MEMORANDUM

REVIEW TYPE: Preliminary Plan of Subdivision, Resubdivision of Existing Lot 42, Block 17

PROJECT NAME: Bradmoor

CASE #: 120070240

PRELIMINARY SUBDIVISION
PLAN

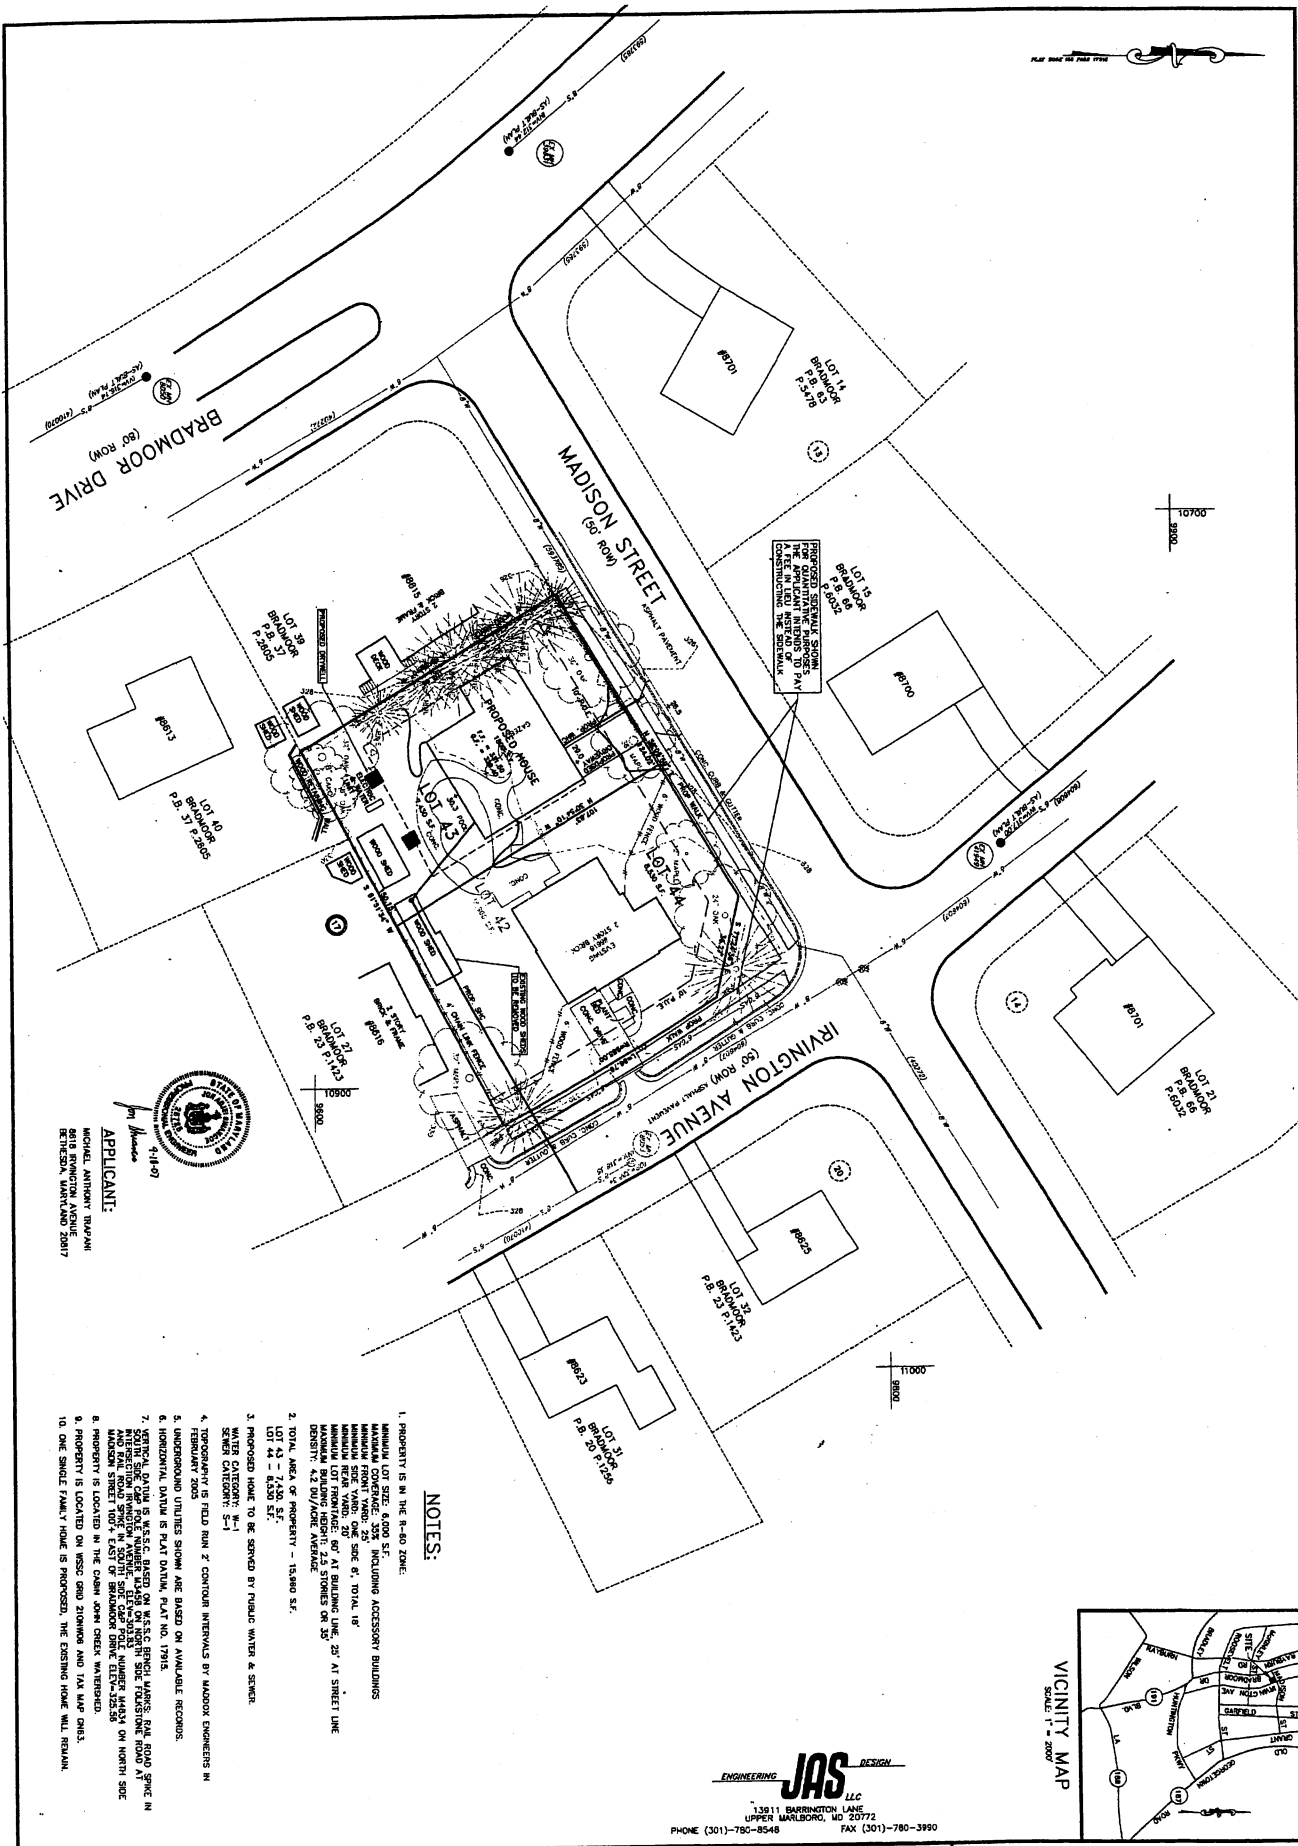
1. Show/label all existing planimetric and topographic details specifically storm drainage, driveways adjacent and opposite the site as well as existing rights of way on both sides and easements on the preliminary plan.

2. Necessary dedication for Madison Street and Irvington Ave.
3. Grant necessary slope and drainage easements. Slope easements are to be determined by study or set at the building restriction line.

6. In accordance with Section 49-35(e) of the Montgomery County Code, sidewalks are required to serve the proposed subdivision. Sidewalks are to be provided along the site frontage according to associated DPWT standard street section unless the applicant is able to obtain a waiver from the appropriate government agency.

7. In accordance with Section 50-35(n) of the Montgomery County Code, we recommend the Montgomery County Planning Board require the applicant to construct an off-site sidewalk along Madison Street to Bradmoor Drive.

PROPOSED SIDEWALK & SIGNING FOR THE APPLICANT INTENDING TO PAY FOR THE CONSTRUCTION OF THE SIDEWALK.

DATE	REVISION
09-17-07	ADD PROPOSED SIDEWALK
